THERMOTITE DOOR MODEL : 823C

PROJECT : STENNIS MAINT. BLDG
3-16-09 REVISED

BROADMOOR, L.L.C.

Submittal Item: Overhead Doors
Comments

COILSIDE ELEVATION
RIGHT HAND OPERATED DOOR SHOWN
LEFT HAND OPERATED DOOR OPPOSITE

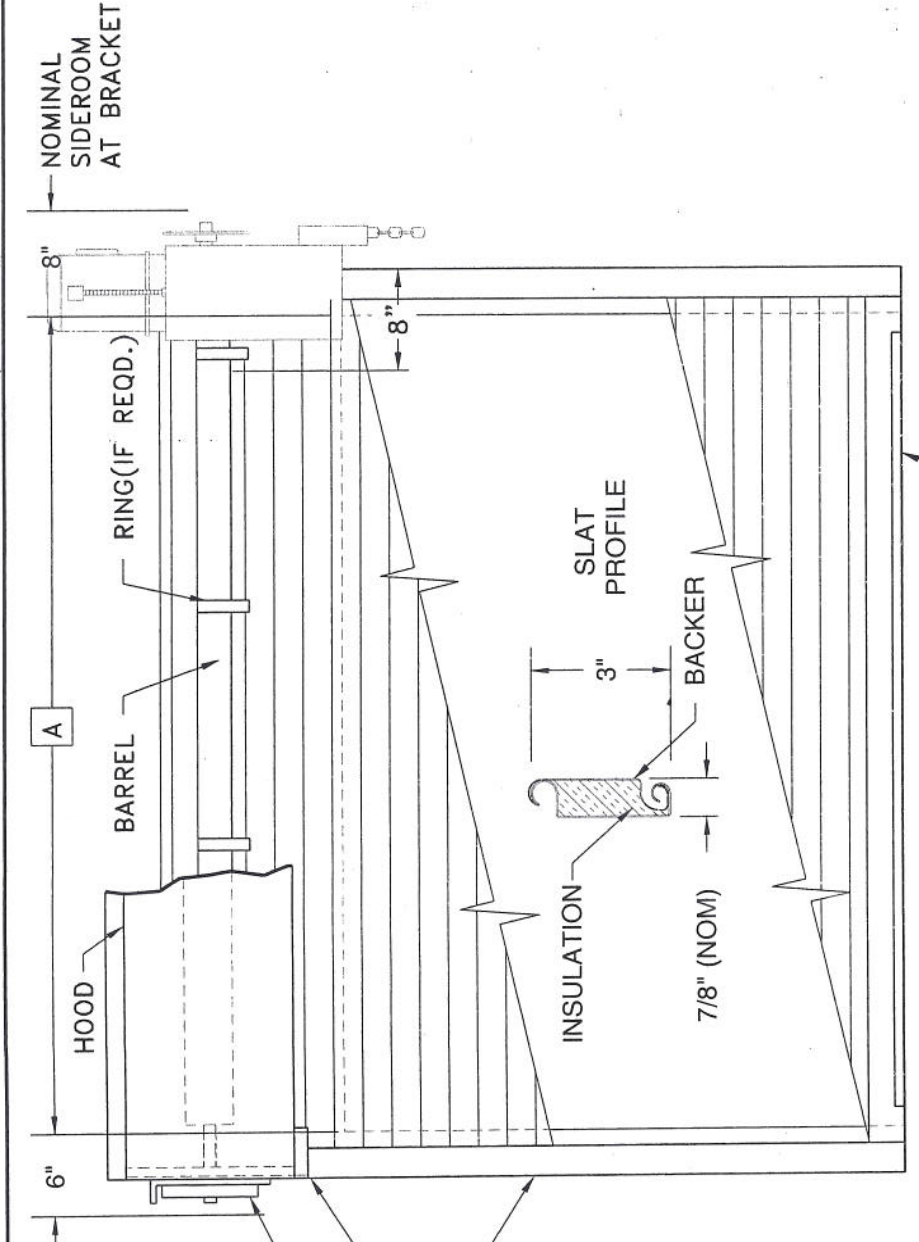
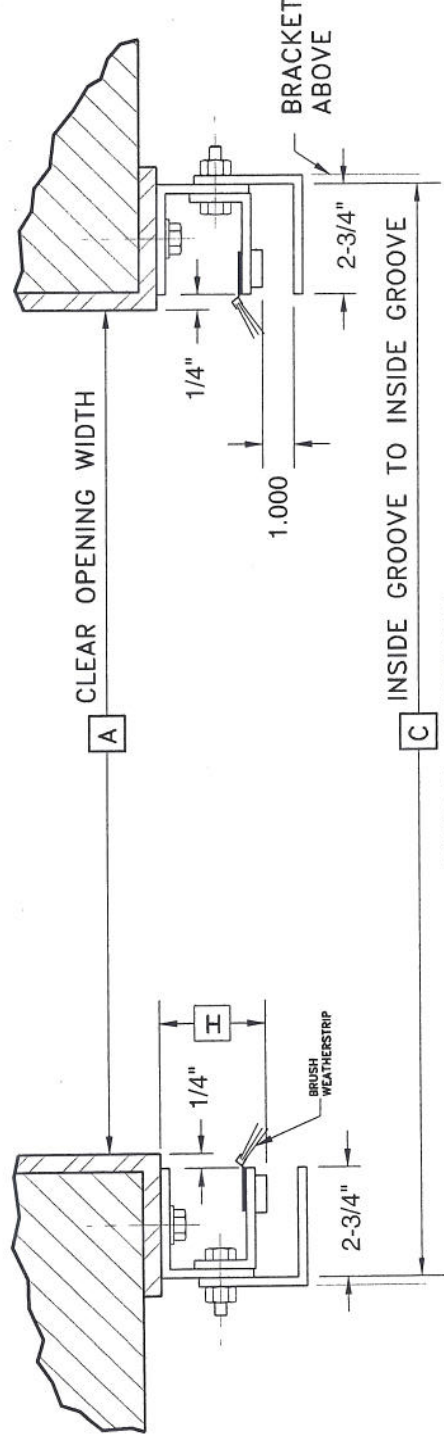
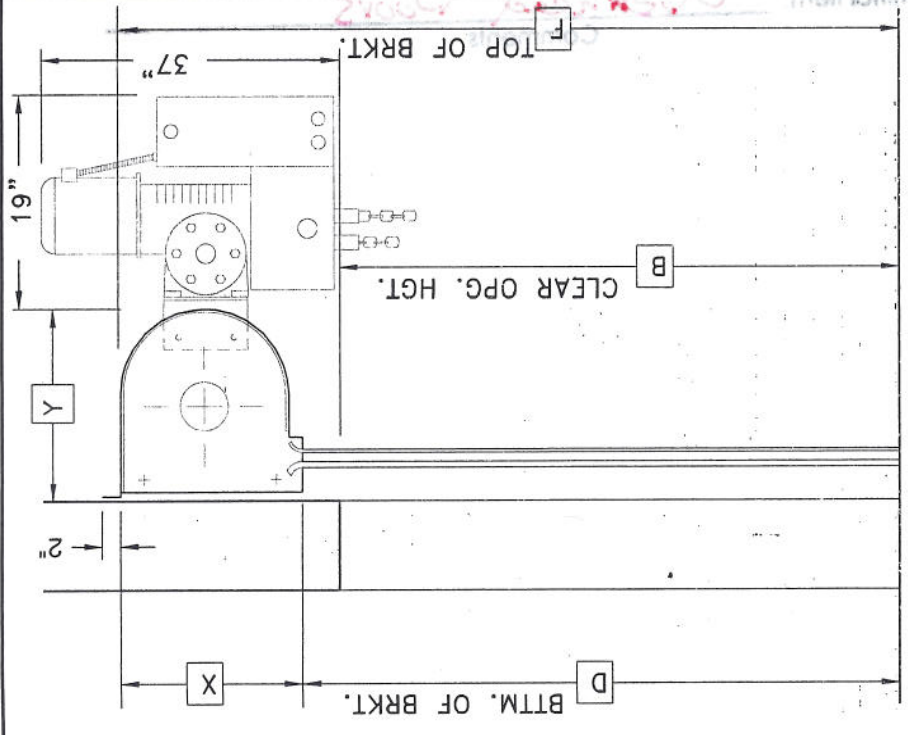
- Door to be hot dip galv. with Painted Finish
- Switch to be 3 button

Date: 4.28.09 Project: Sternis ROF
Reviewed: _____
Reviewed as Noted: X
Revise and Resubmit: _____
Rejected: _____
Other: _____
